**HYDROMODIFICATION MANAGEMENT
STUDY FOR
MEADOWOOD VESTING TENTATIVE MAP**

Job Number 15956

**April 1, 2009
Revised: August 18, 2009**

**RESPONSE TO COUNTY'S COMMENTS FOR THE
HYDROMODIFICATION MANAGEMENT STUDY FOR
MEADOWOOD VESTING TENTATIVE MAP**

Meadowood Vesting Tentative Map - POC 7A & 7B (Interim Condition)

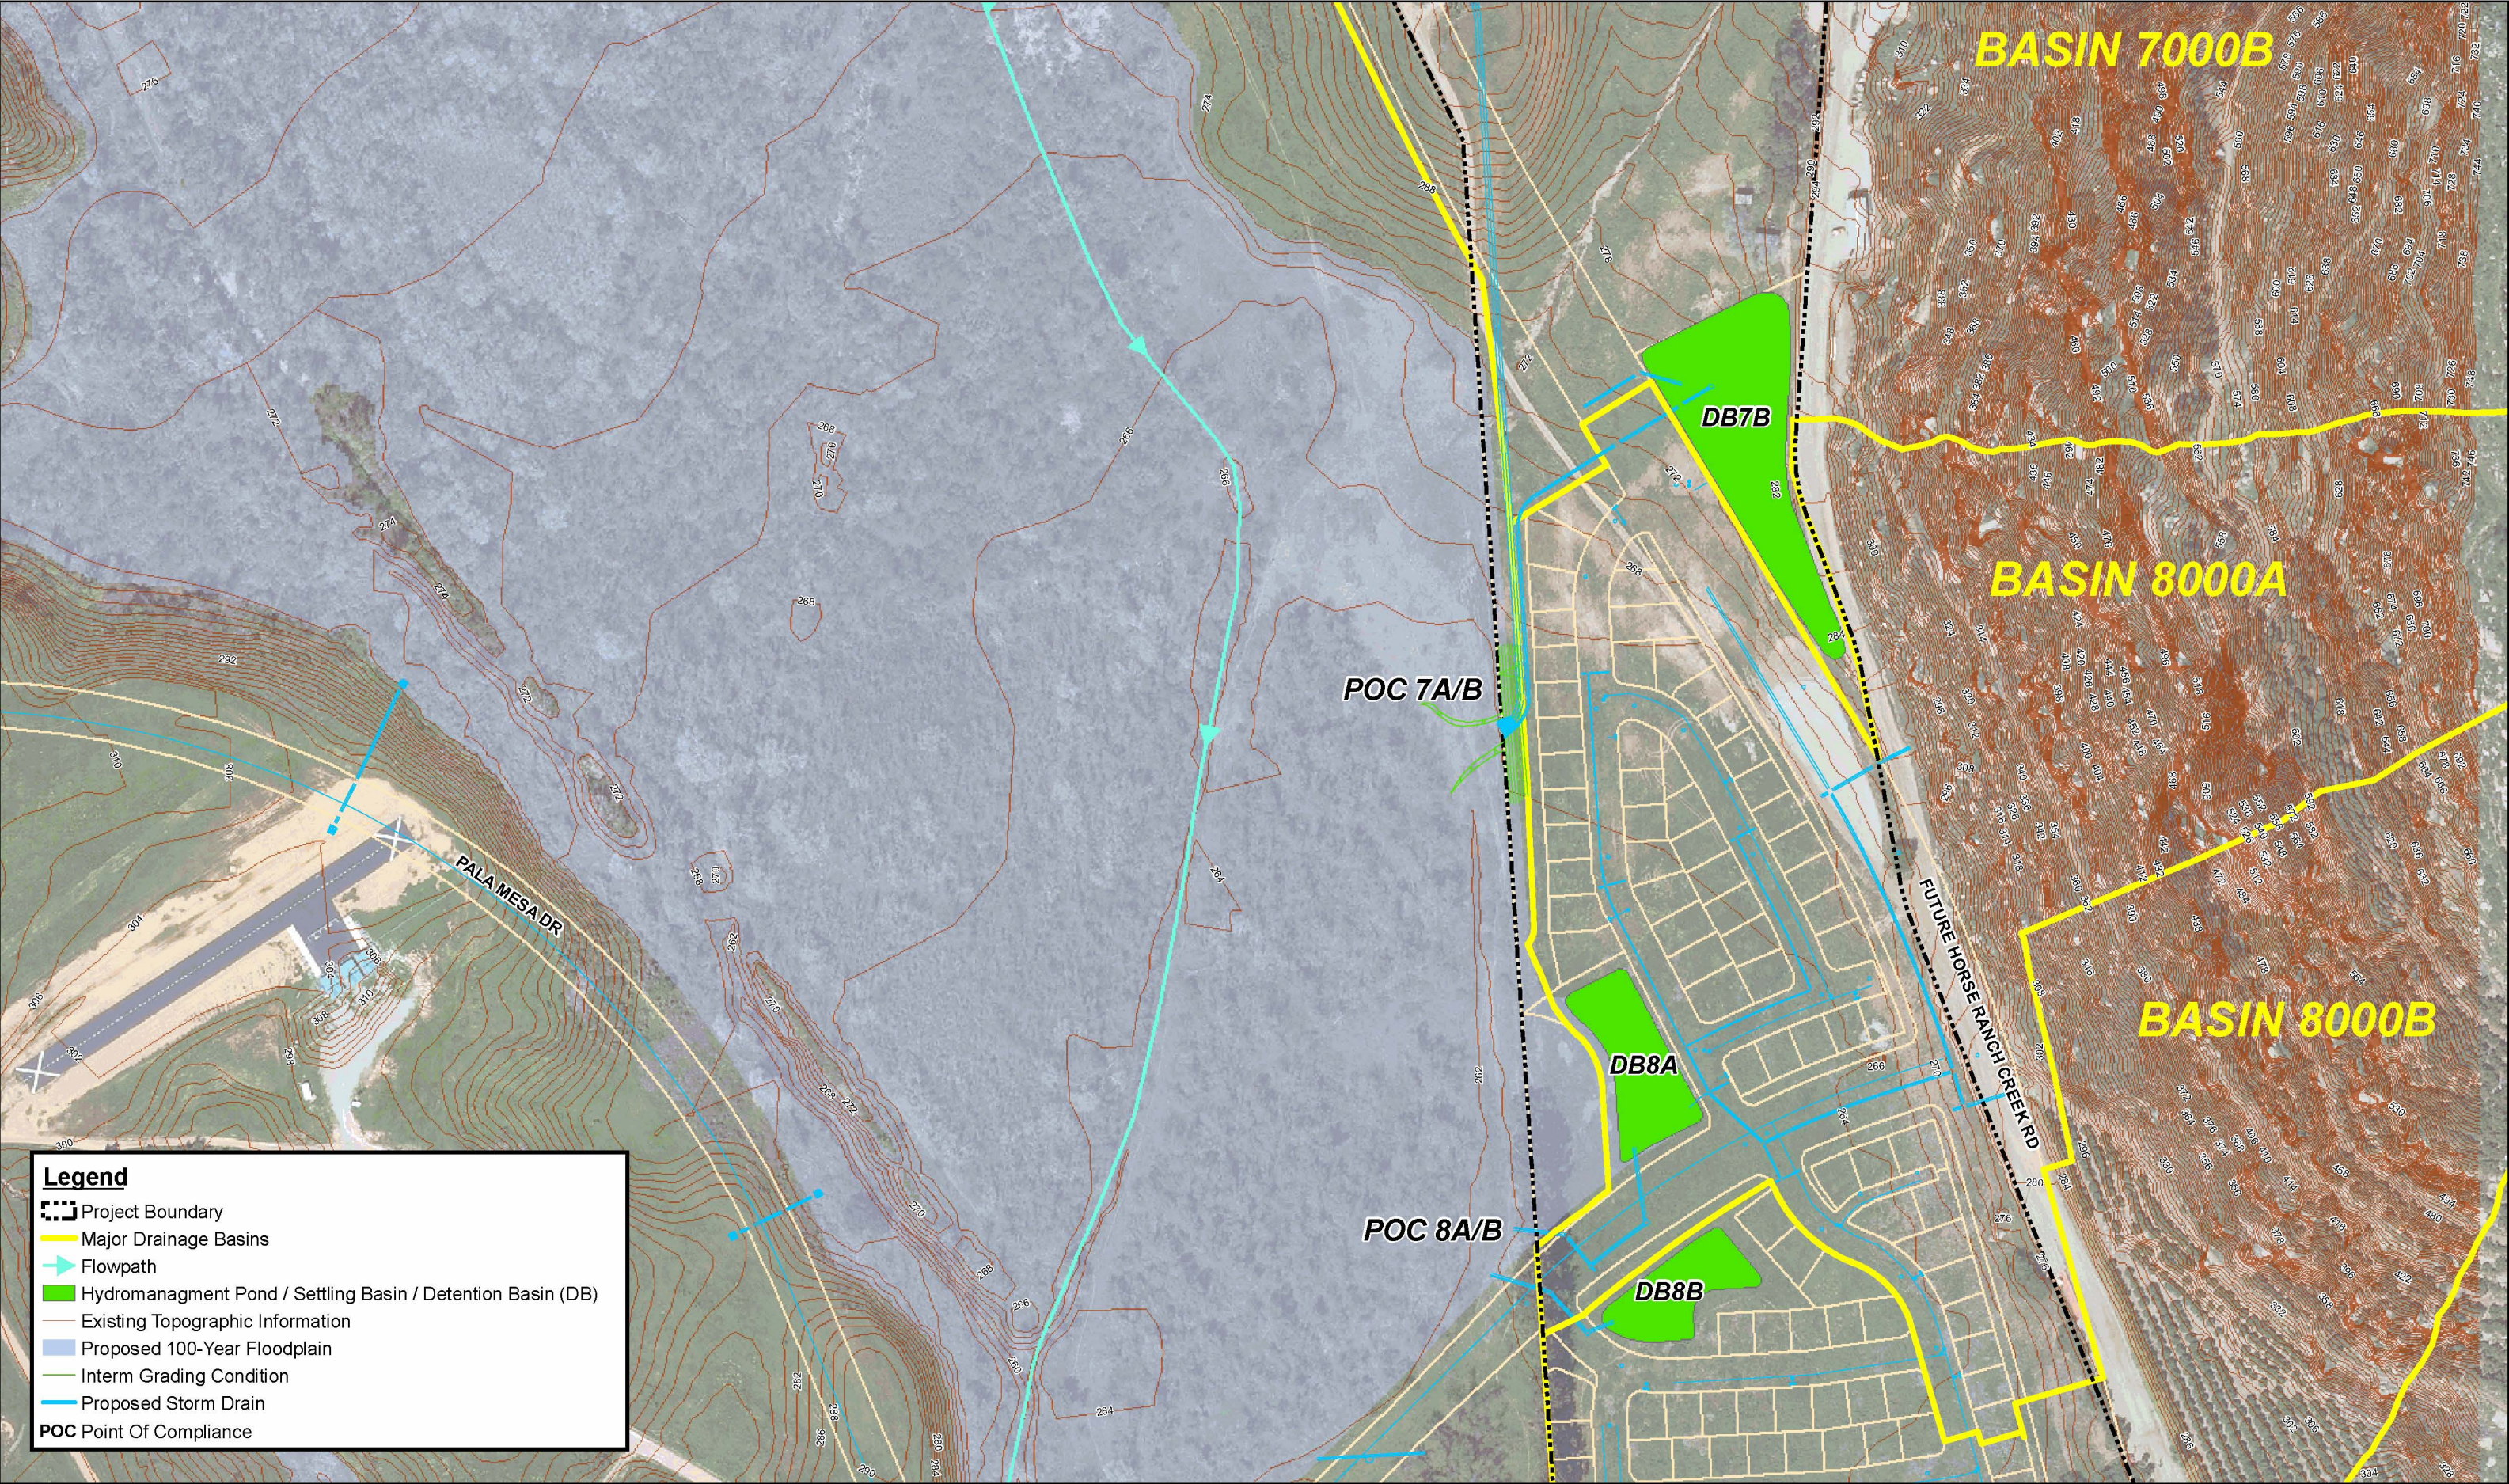
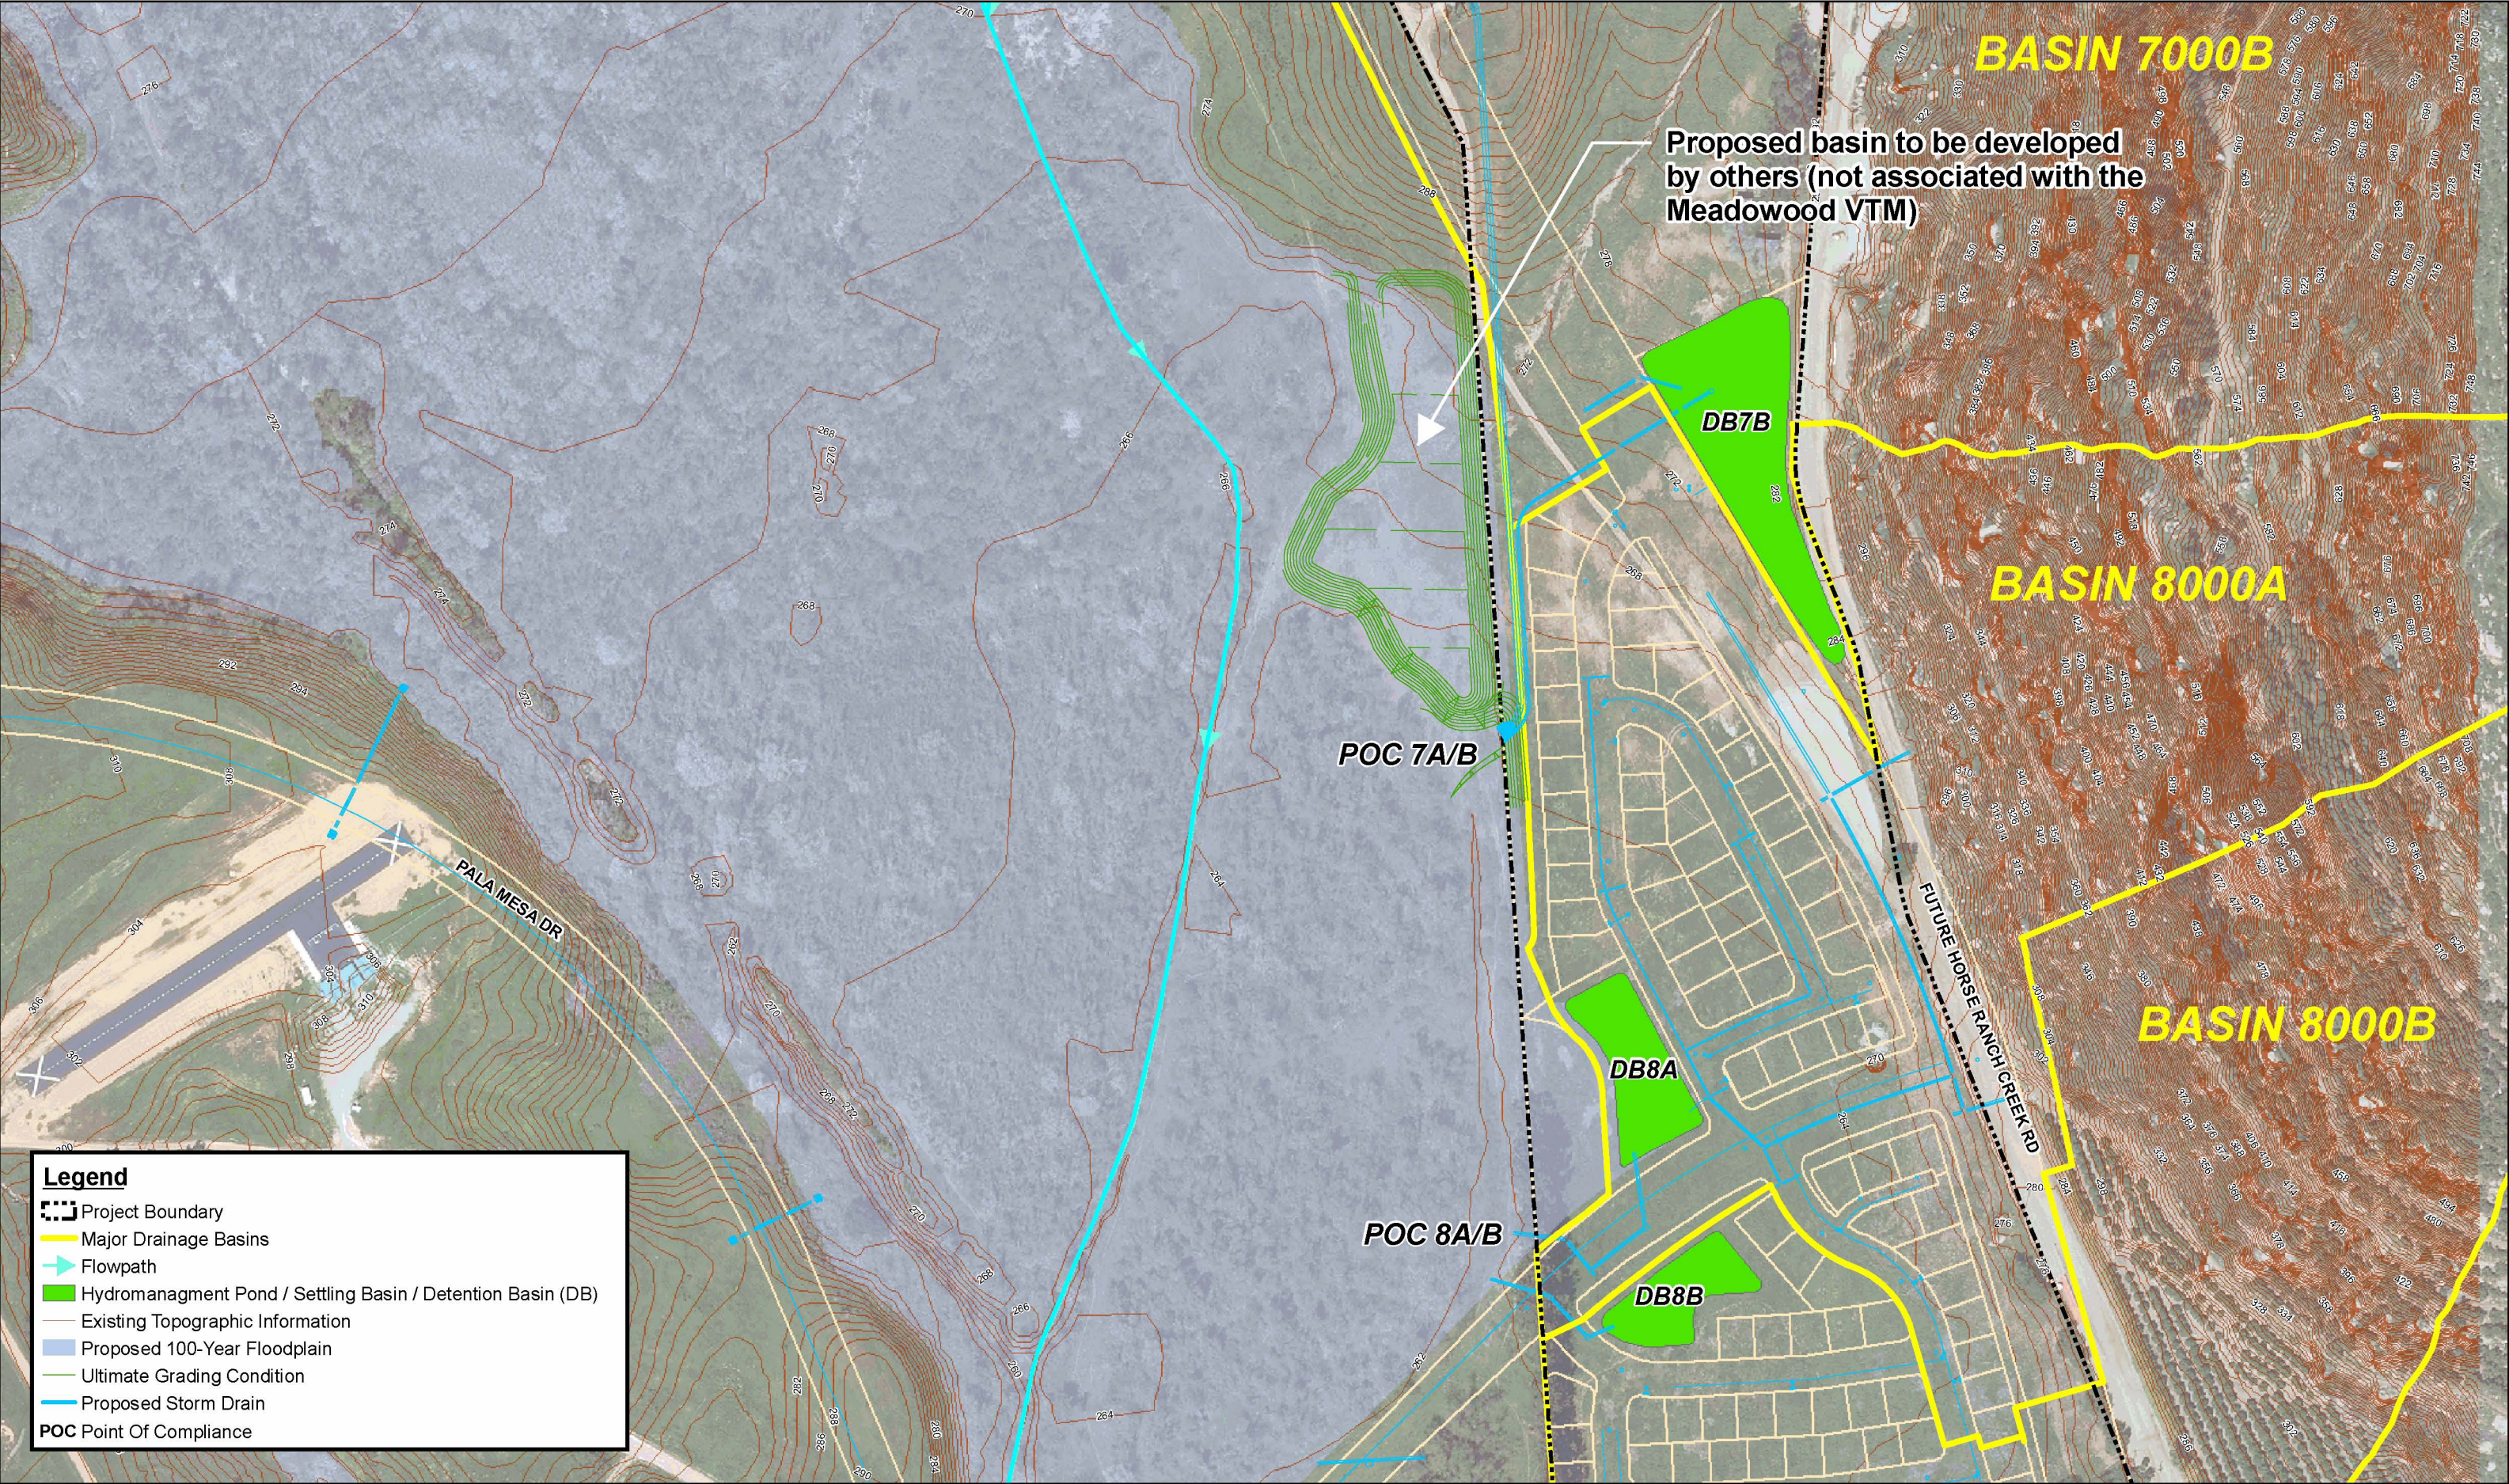
1. *The pre-project drainage maps provided in the Meadowood Drainage Study show distinct discharge points for Drainage Basins 500, 600, and 700A/700B. For evaluating compliance with HMP regulations, it does not appear to be reasonable to combine Drainage Basins 500, 600, and 700A into a single basin, resulting in a single Point of Compliance (POC) for these basins. Instead, separate POCs are required for each of these drainage basins, as described below.*

Drainage Basins 700A and 700B. As outlined in the County's comments regarding the Meadowood Drainage Study, the delineation of Drainage Basins 700A and 700B requires reexamination. Drainage Basin 700A is currently modeled with an outlet at Node 712, while flow from Drainage Basin 700B discharges at Node 753 (see Figure 2). However, it appears from the Pre-Project Drainage Map (dated November 14, 2008) that much of the flow from 700A would actually combine with flow from 700B, with the combined flow discharging at Node 753. Therefore, a single POC could potentially be used for these two drainage basins unless significant flow actually reaches Node 712. In the latter case, two POCs would be required: at Node 753 and Node 712.

Rick Engineering Company's Response: As discussed at the meeting at the Regional Board with County of San Diego, Pardee Homes, and Rick Engineering Company representatives the project is assigning the point of compliance for Drainage Basin 7000 (7000A and B combined) at the point in the system that needs to be protected rather than the project boundary. As a result the POC has been identified on the updated exhibit located in the revised report. Further discussion of this has been included in the updated text.
